City of Albuquerque

RE: CONCEPTUAL DRAINAGE PLAN FOR AN ADDITION TO FOOTHILLS
FELLOWSHIP (K-23/D24) ENGINEER'S STAMP DATED AUGUST 29, 1991

CONCEPTUAL
GRADING AND DRAINAGE PLAN
FOOTHILLS FELLOWSHIP

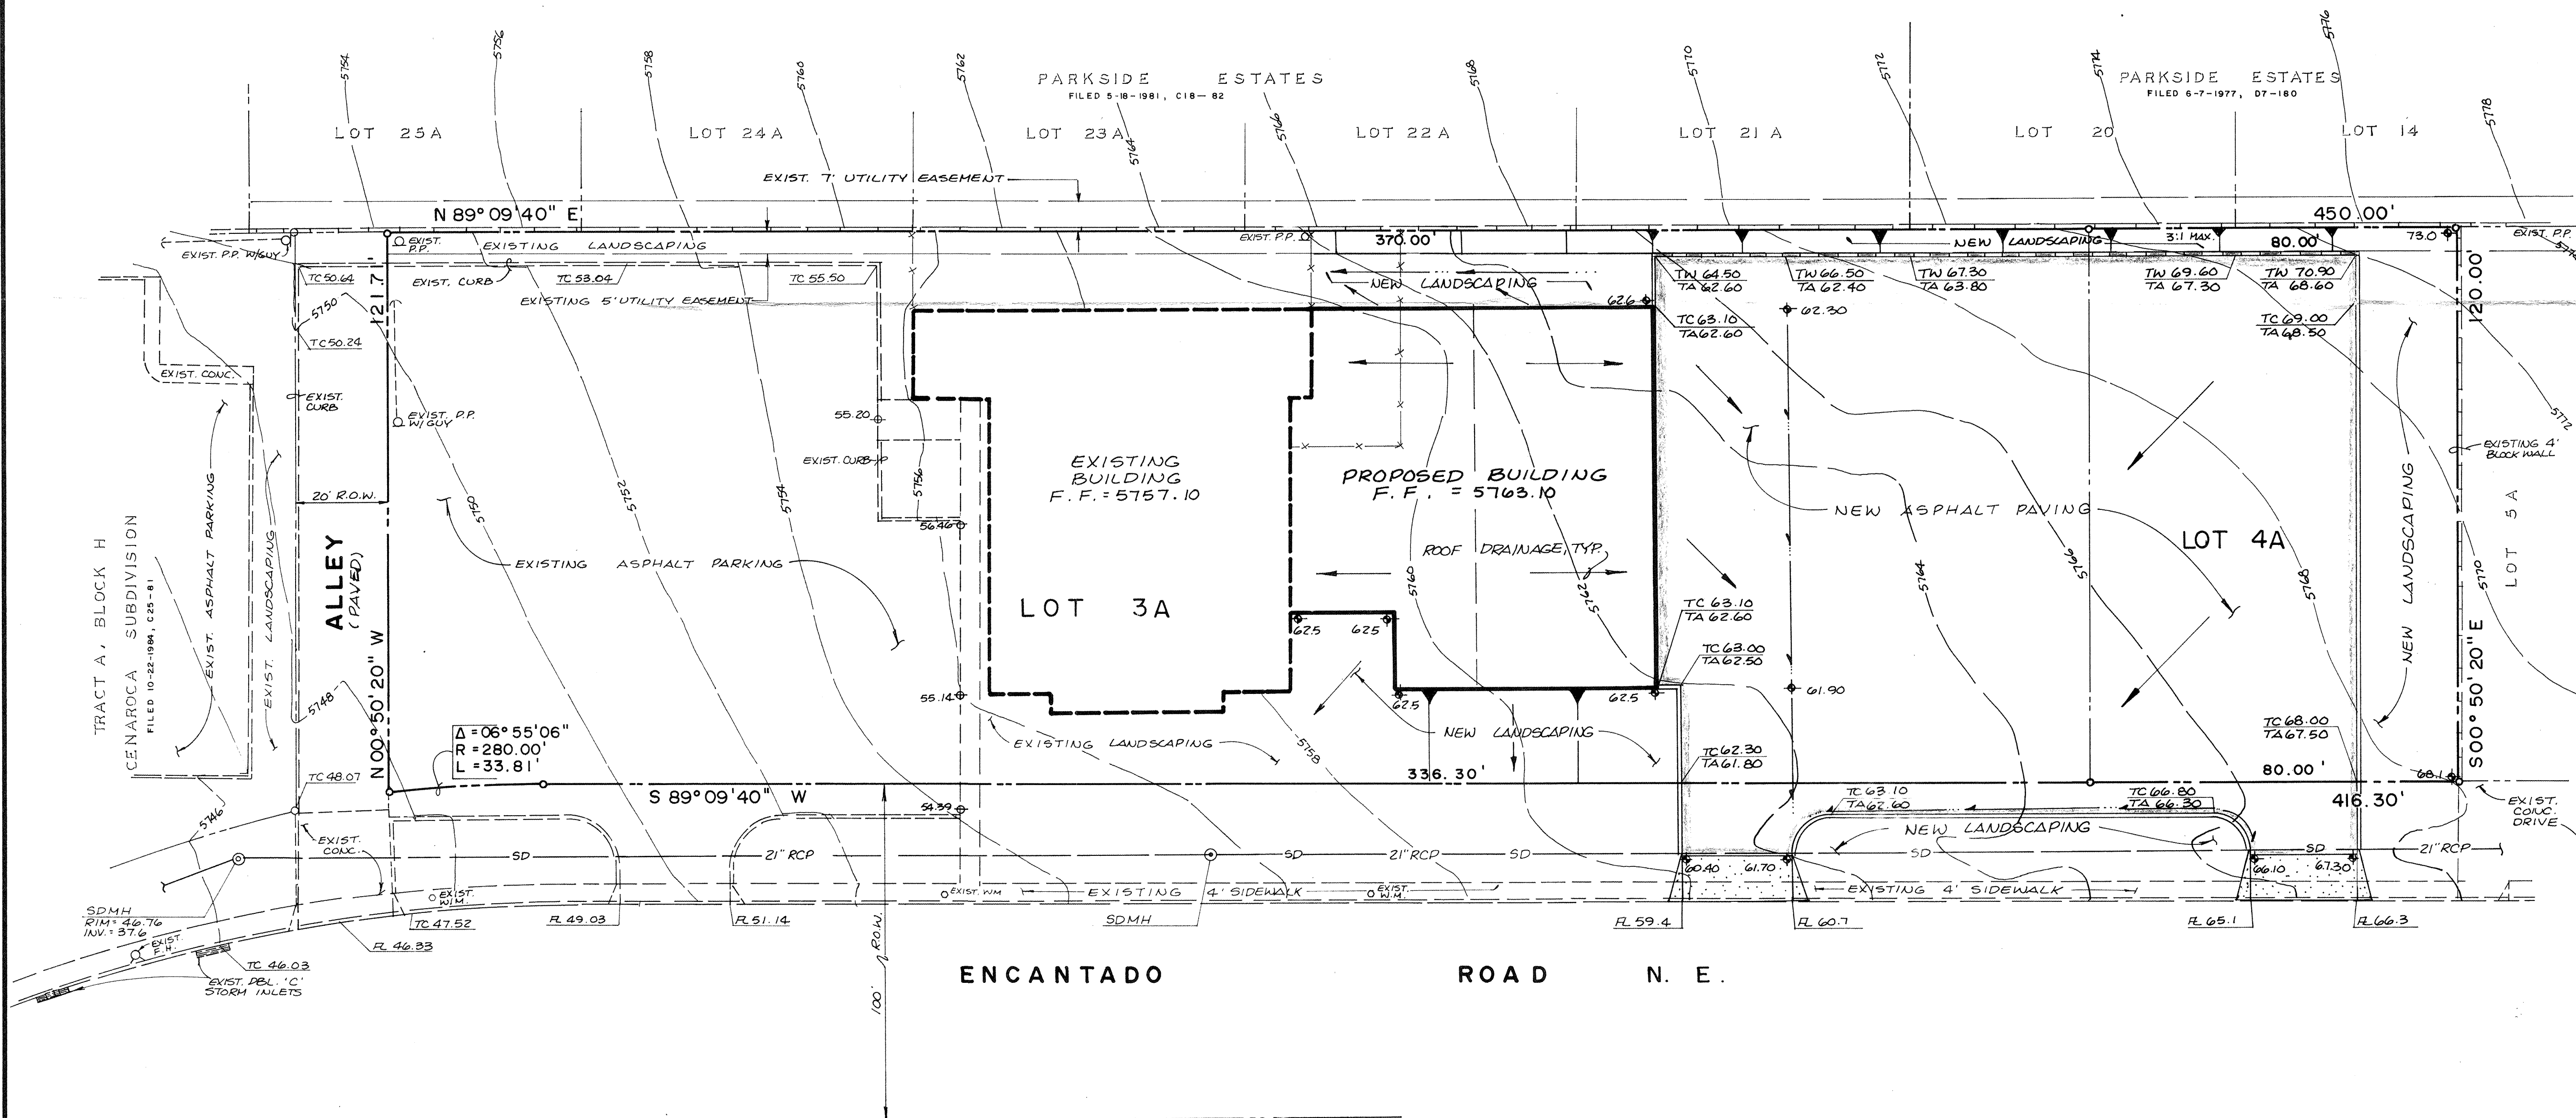
Based on the information provided on your submittal of August 30, 1991, the above referenced plan is approved for Site Development.
